**METZGER PARK BASEBALL & SOFTBALL FIELDS**

**ADDENDUM #3**

**September 18, 2023**

**THRASHER PROJECT #101-T30-11111**

UTILITY PLAN-2

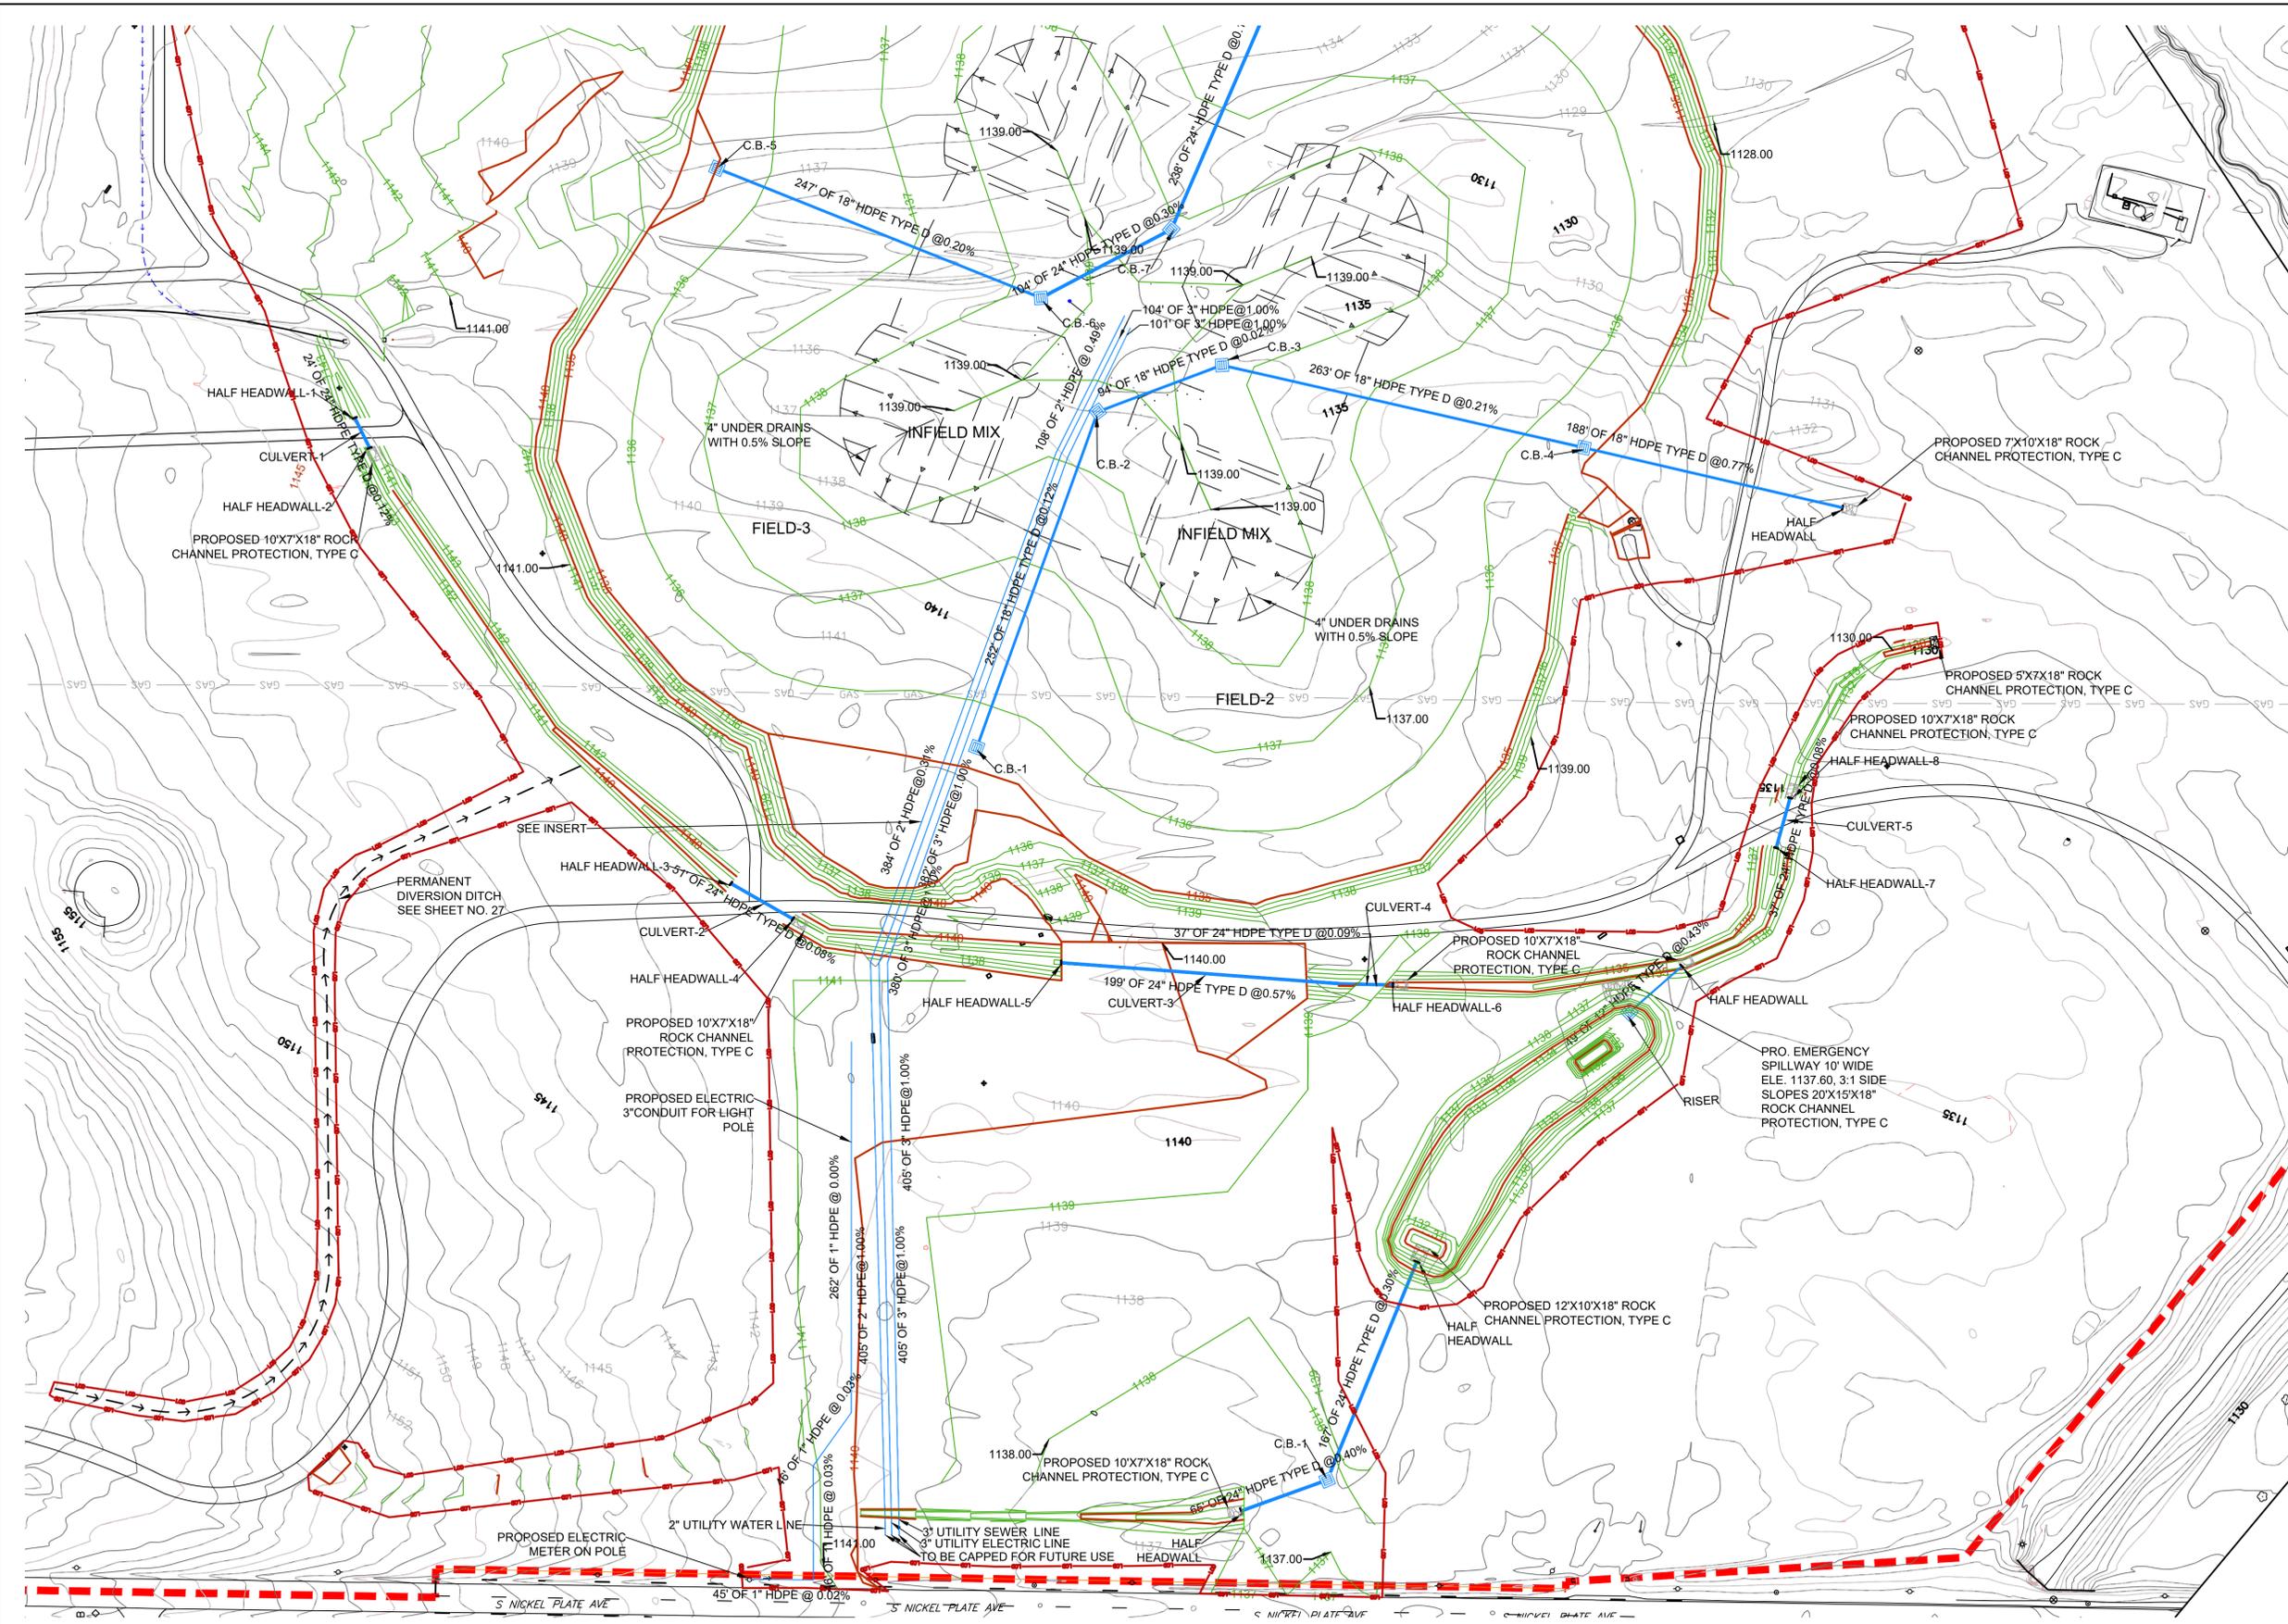
1. Under what bid item is the trucking, placing, and compacting of the city supplied millings being paid under? I do not see an item for that. Also, the plans show 6" base of 304 under the millings. I know there is a 304 item in the bid, but 278 CY barely covers the 4" trial portion. There is a considerable amount of 304 required in the parking lot portion.

**The contractor is to strip and stockpile the topsoil, grade, compact subgrade, and install the curb. The city will place 304 and millings. Plans show 4" 304 aggregate base for under the path. **The note on Sheet 11 has been revised. (see attached).****

3  
 THE CONTRACTOR IS TO REMOVE THE ASSUMED 12" OF TOPSOIL AND STOCKPILE IT AS SHOWN ON THE PLANS, GRADE, AND COMPACT THE SUBGRADE, INSTALL THE 6"X18" CURB.
